Susquehanna Learning Center
Formal Post-Examination Comment Q2
PLA 006380

In accordance with the guidance provided in NUREG 1021, "Operating Licensing Examination Standards for Power Reactors" (Revision 9 Supp 1)) ES-403 "Grading Initial Site-Specific Written Examinations", the following formal post exam comment is being submitted to justify changing the answer key for Question #2 of the Susquehanna Initial Licensing Examination that concluded on May 16, 2008.

Enclosures: SSES RO Written Exam Question #2 – Justification, Dated 05/29/2008

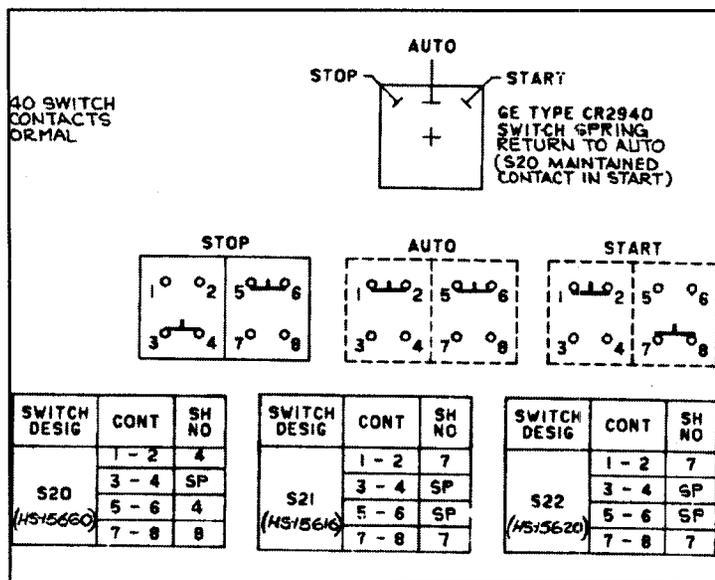
Refer to the following logic prints (ref. 1 and 2): When relay K6 is energized, contacts 3 and 4 close which energize relay K60 in the HPCI Aux Oil Pump control logic. Relay K60 is sealed-in through the HPCI Aux Oil Pump control switch (HS-15660) identified as (S20).

The switch development for the HPCI Aux Oil Pump Control Switch (S20) is provided below (ref. 1). Control switch (S20) contacts 5 and 6 are closed in STOP or AUTO, and contacts 1 and 2 are closed in AUTO or START.

Since the HPCI Aux Oil Pump control switch is maintained in the AUTO position, relay K60 remains energized and sealed-in until the HPCI Aux Oil Pump control switch is taken out of the AUTO position.

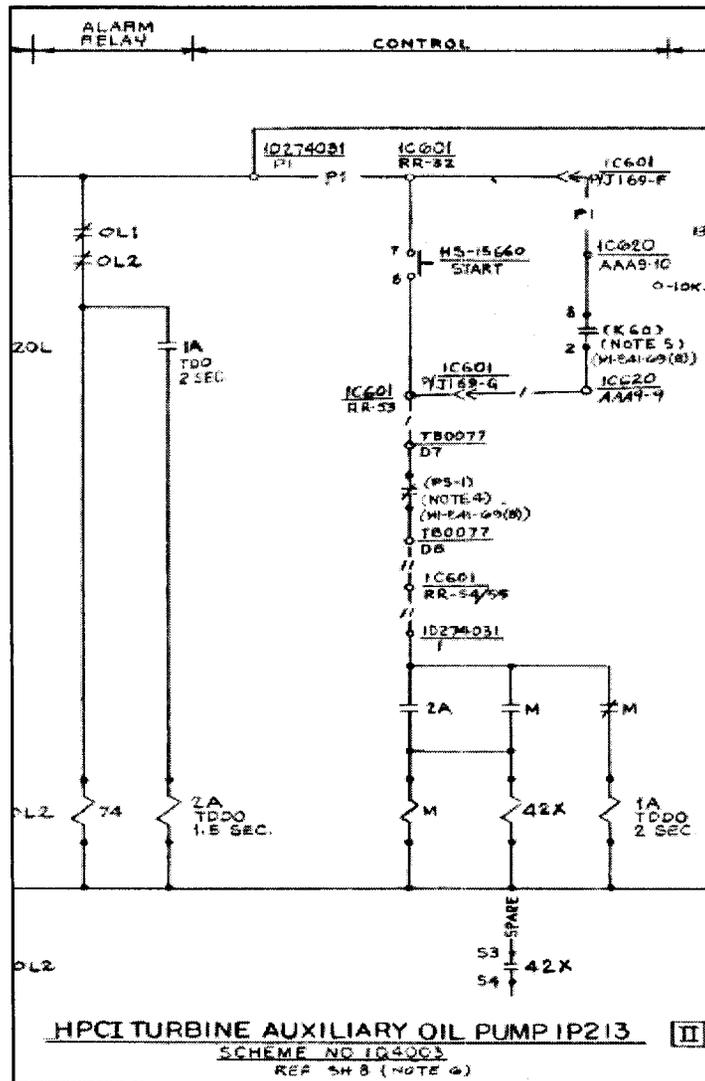
Refer to the following logic print (ref. 3): With relay K60 energized, contacts 2 and 8 (in the HPCI Aux Oil Pump control logic for the breaker) will remain closed and the pump will automatically start when oil pressure lowers to 35 psig as sensed by (PS-1).

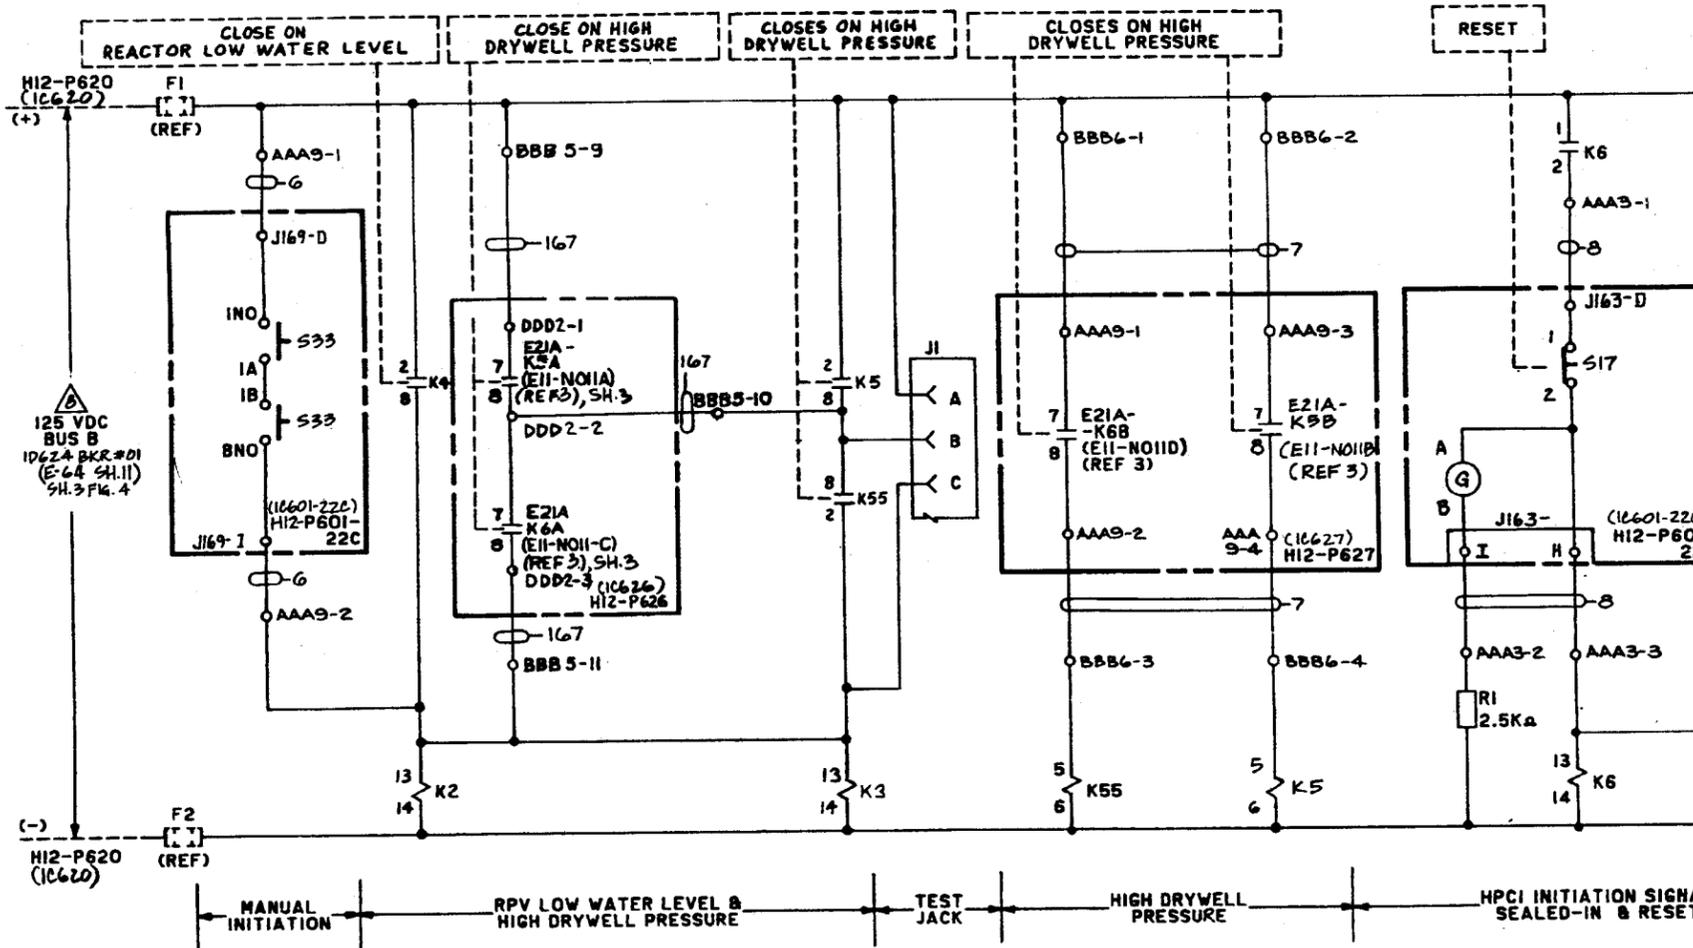
In conclusion, the stem of Question #2 stated that the HPCI initiation signal was generated and subsequently reset by the operator using the HPCI Initiation logic RESET pushbutton (S17) (Relay K6 was energized and subsequently deenergized). Since the HPCI Aux Oil Pump control switch (S20) remained in the AUTO position, relay K60 remains sealed-in and energized which causes the Aux Oil Pump to automatically start when oil pressure lowers to 35 psig.

The training staff recommends that Question #2 choice "C" be the correct technical answer and choice "D" be an incorrect answer. Choices "A" and "B" are still incorrect answers and remain unaffected.
